CALIFORNIA COASTAL COMMISSION

**SUBJECT: REVISED FINDINGS ON CITY OF SAN DIEGO MAJOR LOCAL
COASTAL PROGRAM AMENDMENT #4-2000 (CENTRE CITY—NORTH
EMBARCADERO OVERLAY DISTRICT)**

SD LCPA #4-2000 (CENTRE CITY)
Selected Exhibits Relevant to
Revised Findings

Proposed Waterfront District

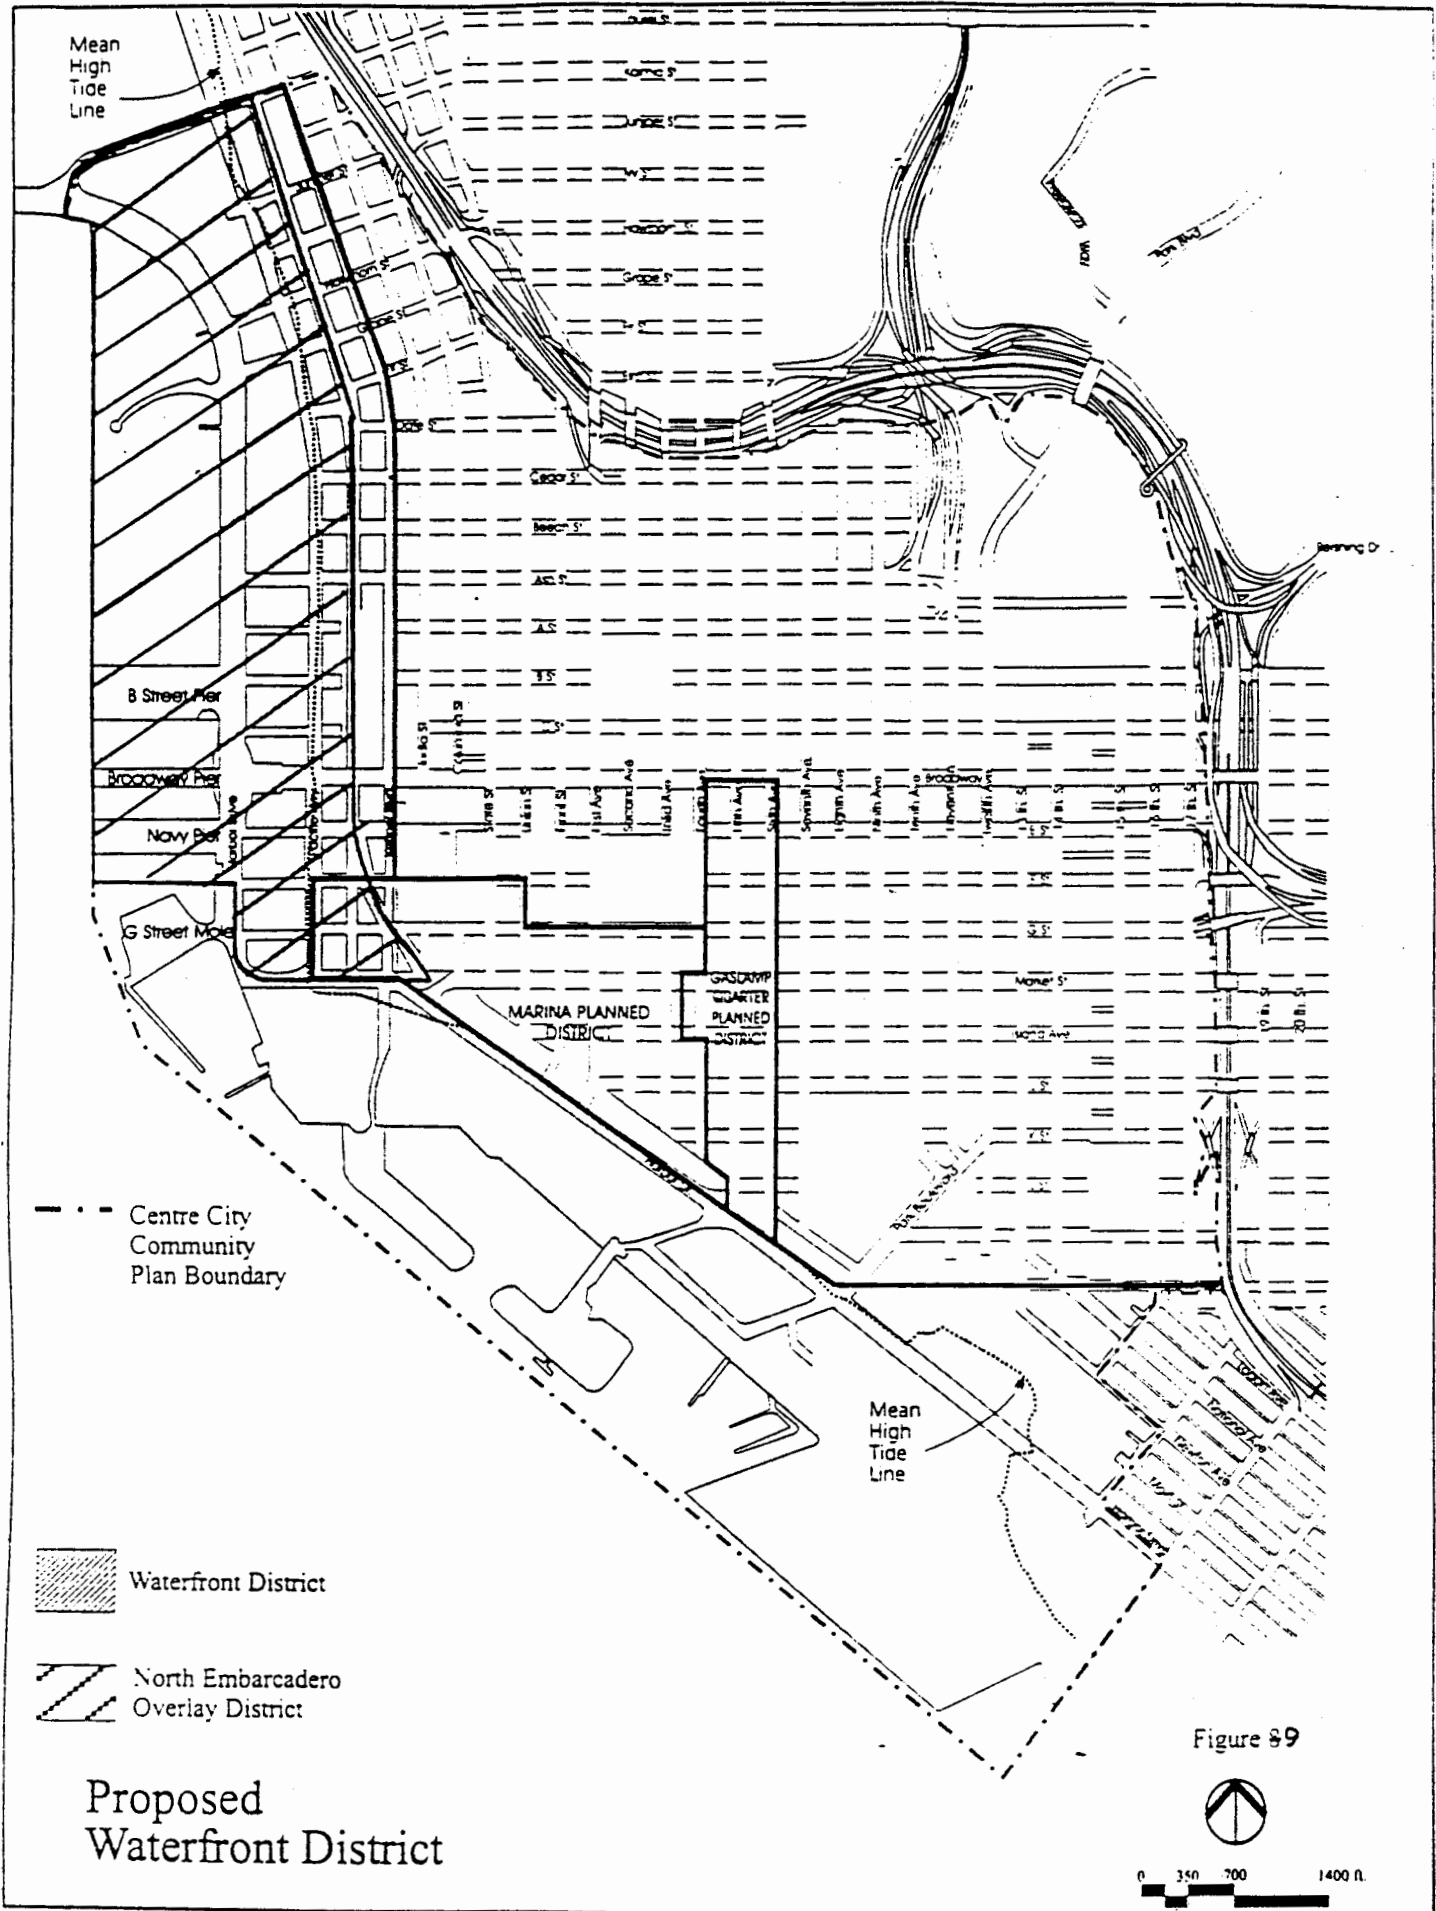
10. The proposed Figure 9, **Waterfront District**, shall be corrected to include a graphic depiction of both the Waterfront District, as shown on the existing Waterfront District figure, and the new North Embarcadero Overlay District (as proposed).
11. Table II of Section 103.1915 **VIEW CORRIDORS**, shall be revised as to increase the setback on Date and Beech Streets west of Pacific Highway, and increase the setback on C Street. As revised, the table will be identical with the View Corridors table in the Community Plan (as modified herein):

Suggested Modification #10 corrects a printing error on the proposed Figure 9, Waterfront District, to graphically depict both the existing Waterfront District and the proposed North Embarcadero Overlay District.

Proposed View Corridor Stepbacks

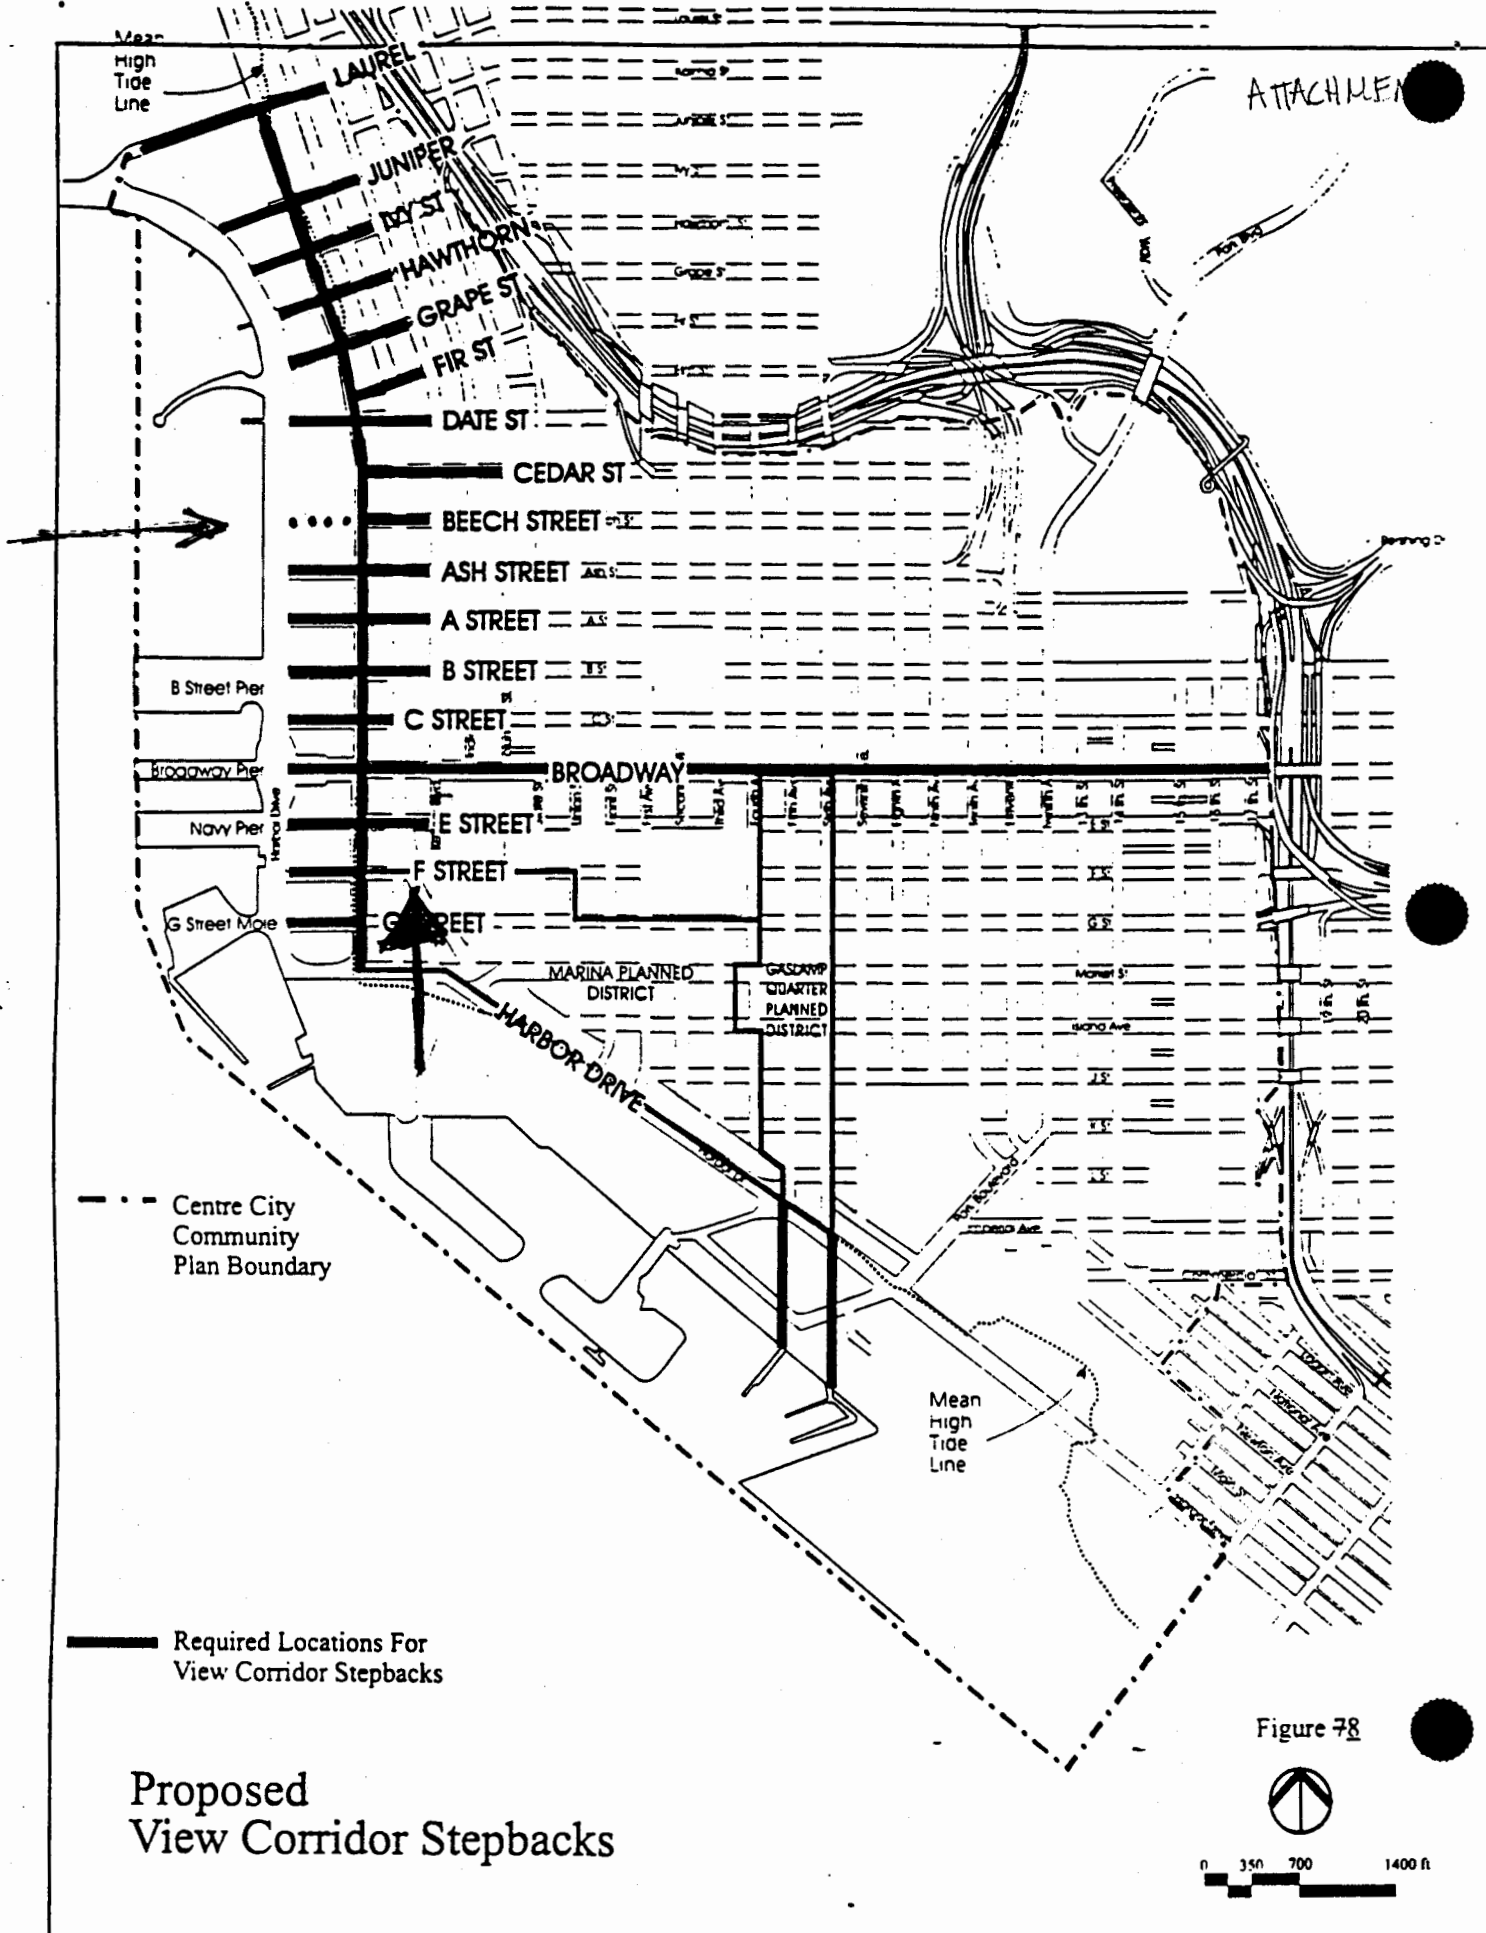
9. The following changes shall be made to the proposed Figure 8, **View Corridor Stepbacks**:

The City has requested several changes to the View Corridor Stepback exhibit, shown on Attachment 3 of Exhibit #15, that were not included in the City's initial amendment submittal. The changes include adding Beech Street west of Pacific Highway as a view corridor (and thus subject to the setback requirements) and extending the view corridor on F Street from Pacific Highway east to Kettner Boulevard. These changes would increase the view protection on these streets, consistent with the policies of the Community Plan. Removal of Pacific Highway as a view corridor would be inconsistent with the Community Plan. Suggested Modification #9 includes the changes to the view corridors on Beech and F Streets, but requires that Pacific Highway remain a view corridor.
